SUBJECT: Reactor Coolant System Flow Measurement Uncertainty for SNUPPS

STATUS OF TECHNICAL SPECIFICATION OPEN ISSUES

PROPOSED TECHNICAL SPECIFICATION
CHANGES AND JUSTIFICATIONS

FIGURE 3.2-3 RCS TOTAL FLOW RATE VS. R
CALLAWAY FOUR-LOOP OPERATION

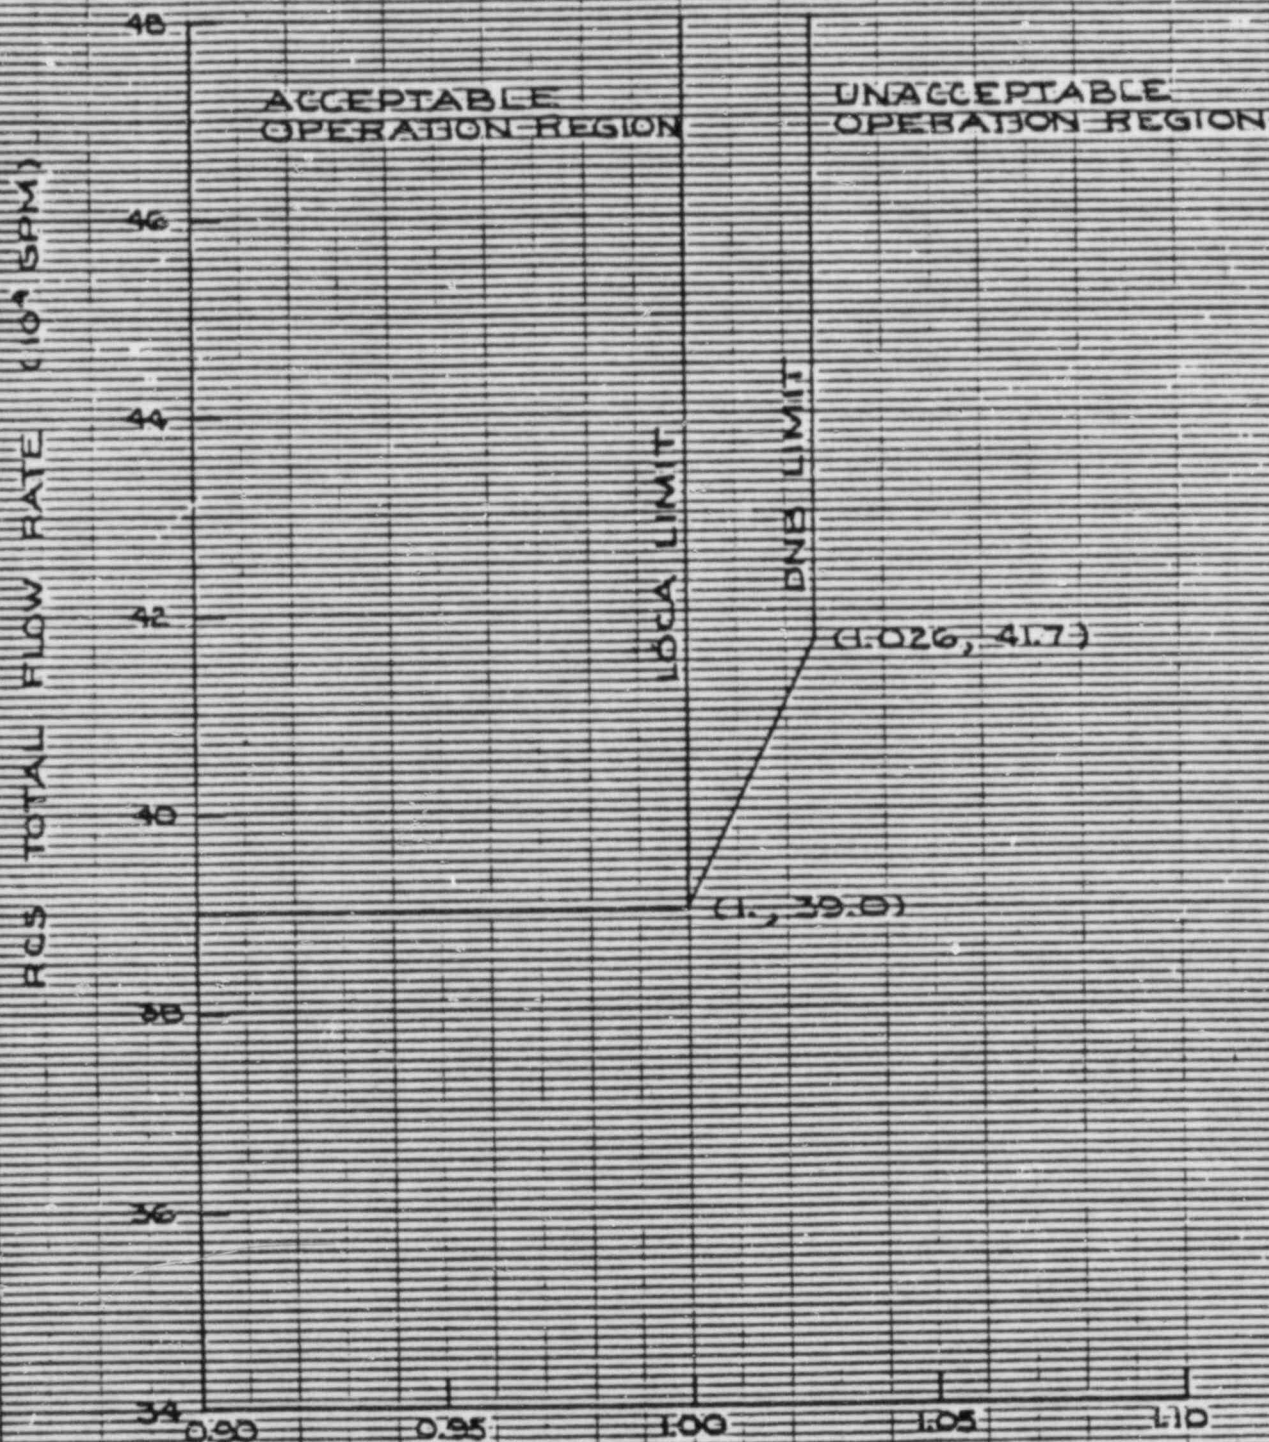
c. $F_{\Delta H}^N$ = Measured values of $F_{\Delta H}^N$ obtained by using the movable incore detectors to obtain a power distribution map. The measured values of $F_{\Delta H}^N$ shall be used to calculate R since Figure 3.2-3 includes penalties for ~~undetected feedwater venturi fouling of 0.1% and for measurement uncertainties of 2.0% for flow and 4% for incore measurement of~~ $F_{\Delta H}^N$

- 4.2.3.4 The RCS loop flow rate indicators shall be subjected to a CHANNEL CALIBRATION at least once per 18 months.
- 4.2.3.5 The RCS total flow rate shall be determined by precision heat balance measurement at least once per 18 months. Insert A, following page

- 4.2.3.6 Insert B, following page

MEASUREMENT UNCERTAINTIES OF
2.0% FOR FLOW AND 4.0% FOR INCORE
MEASUREMENT OF F_{DH}^N ARE INCLUDED
IN THIS FIGURE.

- 4.2.3.5 (cont) Within seven days prior to performing the precision heat balance, the instrumentation used for determination of steam pressure, feedwater pressure, feedwater temperature, and feedwater venturi delta P in the calorimetric calculations, shall be calibrated.

- 4.2.3.6 The feedwater venturi shall be inspected for fouling and cleaned as necessary at least once per 18 months.

FIGURE 6.2-2
UNIT ORGANIZATION

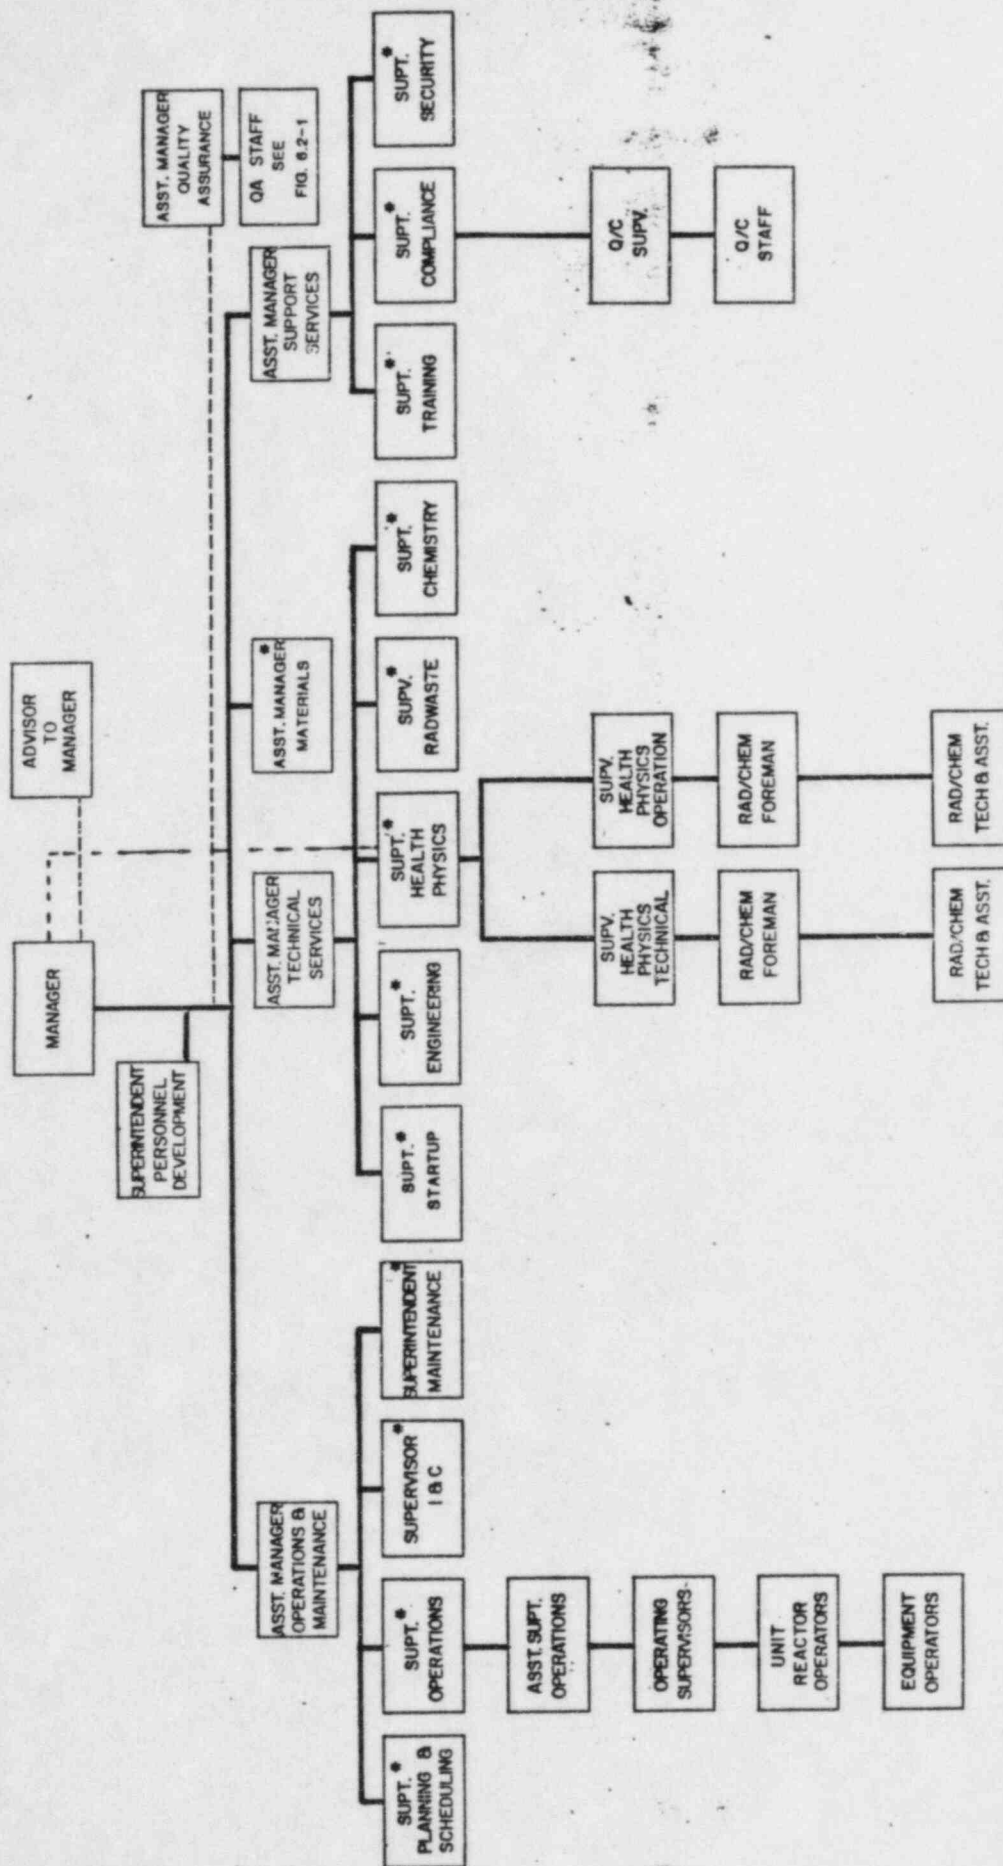
4.8.1.1.3	Diesel Generator Voltage Requirements	Expand allowable voltage range.	Included in Attachment 2
Tab 3.8-1	Containment Penetration Conductor Overcurrent Protection Devices	Correct table values for 13.8 kV switchgear.	Included in Attachment 2
Fig 6.2-1 Fig 6.2-2	Organizational Charts	Provide up-to-date versions of the organizational charts for Callaway.	Included in Attachment 2

FIGURE 1
RCS FLOW CALORIMETRIC SCHEMATIC

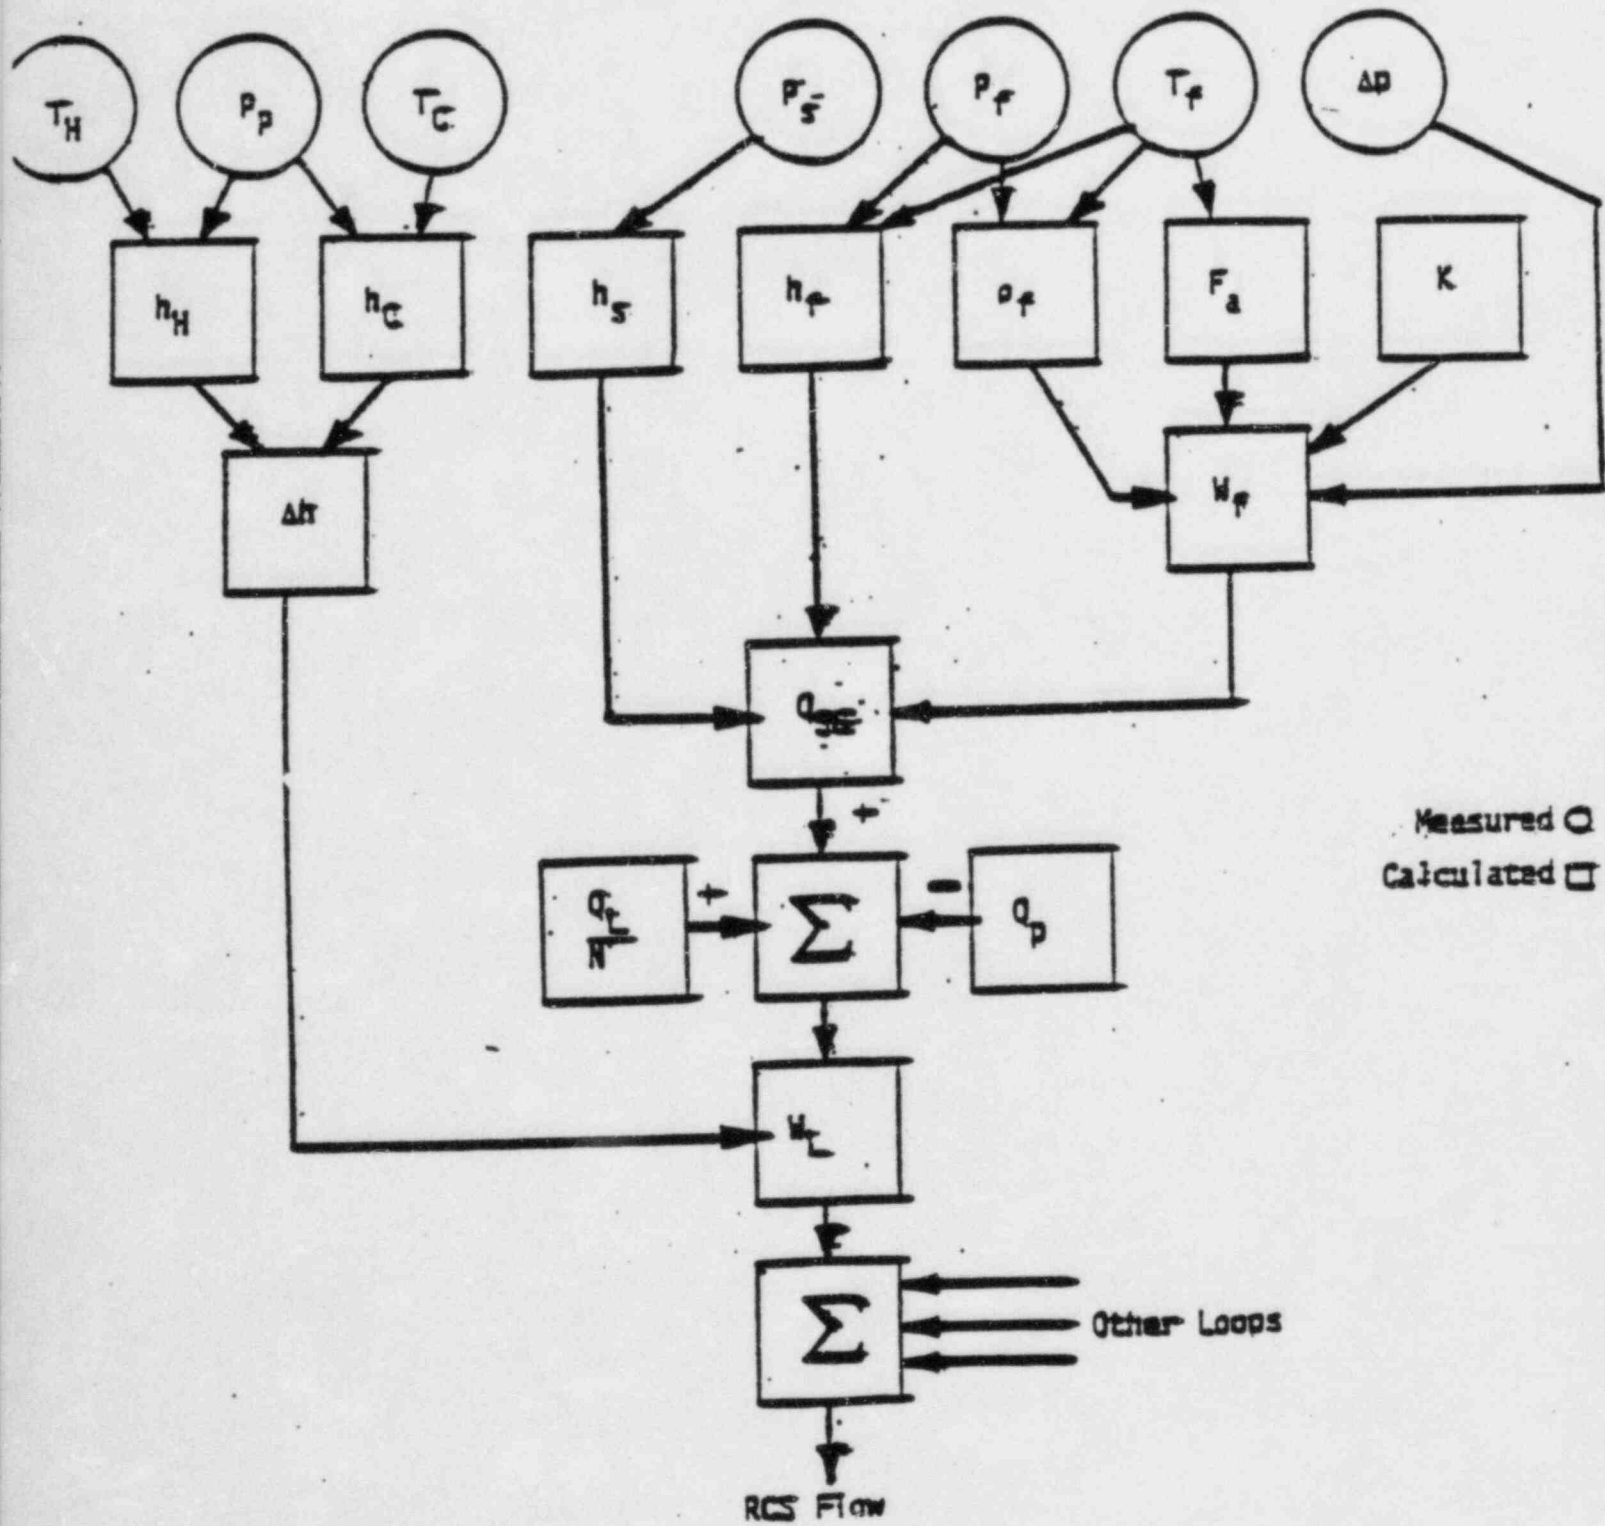
These measurements and calculations are presented schematically on Figure 1.
